The Oil Mining Company, Inc. (TomCo)

Ground Water Discharge Permit No. UGW470003

Comment Response Summary

Utah Division of Water Quality

Figure 4. Generalized Stratigraphic Column Showing Relationship of Mahogany Zone and Douglas Creek Member (after Morgan Rosenberg, U. of Utah)

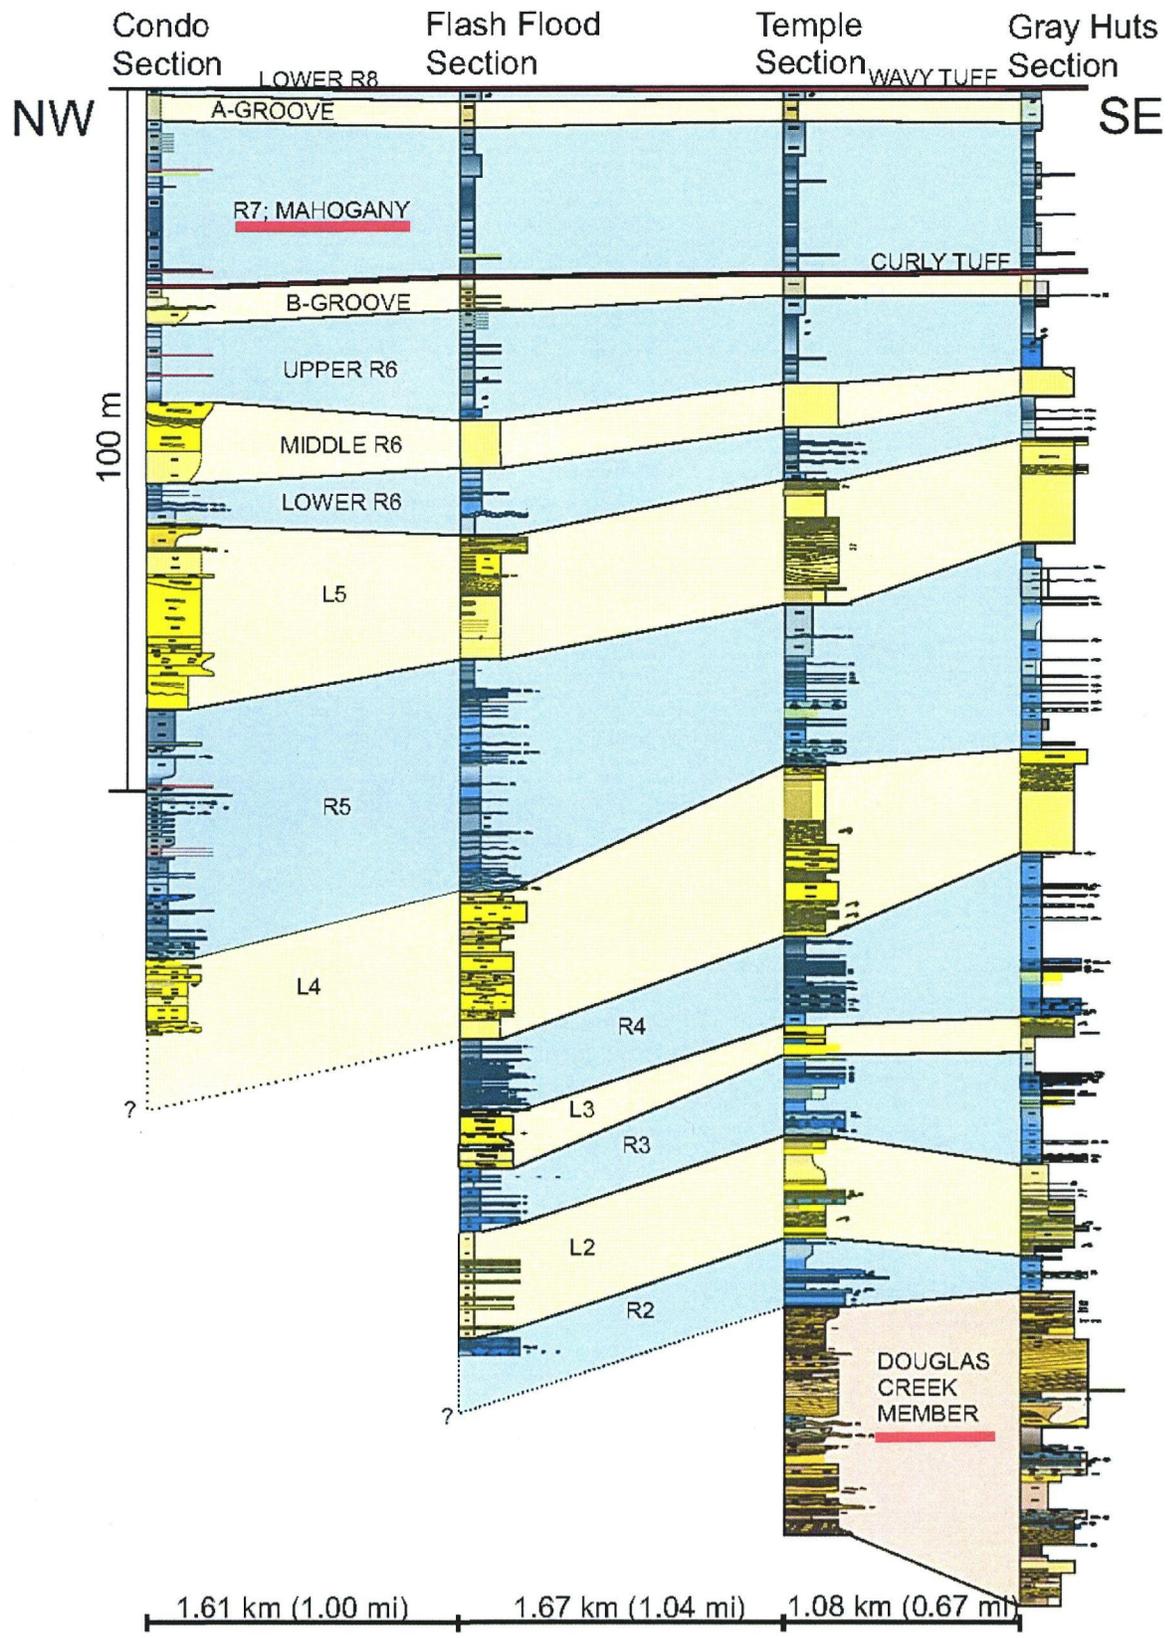
However, while the Application contains information related to the three monitoring wells, TomCo did not provide the required geologic and hydrologic descriptions for the entire site. While showing that Class II and Class III water exists in shallow aquifers immediately beneath the mine site, TomCo failed to provide information on how the aquifers are connected, the specific flow directions, flow systems characteristics or points of discharge. Lips at 6. Further, Tom Co failed to analyze the significance of secondary porosity, even though the company acknowledged the presence of bedrock fractures that could provide a hydrologic connection between the Parachute Creek Member and the Douglas Creek Member. Lips at 6; see also Application at 44. Additionally, TomCo's application fails to evaluate any hydrologic connection between the aquifers in the Parachute Creek Member and the nearby seeps and springs. Lips at 6. Because the Director does not require TomCo to accurately describe the geology and hydrology of the mine site as required in R317-6-6.3(E) & (K), his decision to approve the GWDP is arbitrary, capricious and a violation of the law.

Examination of drill cores of the Parachute Creek Member do show some fine to medium grained sandstones; however, they are either very poorly sorted (i.e., the rock matrix is sand supported by low-permeability mud), or they have been impregnated with tar and have become impermeable as a result³⁵.
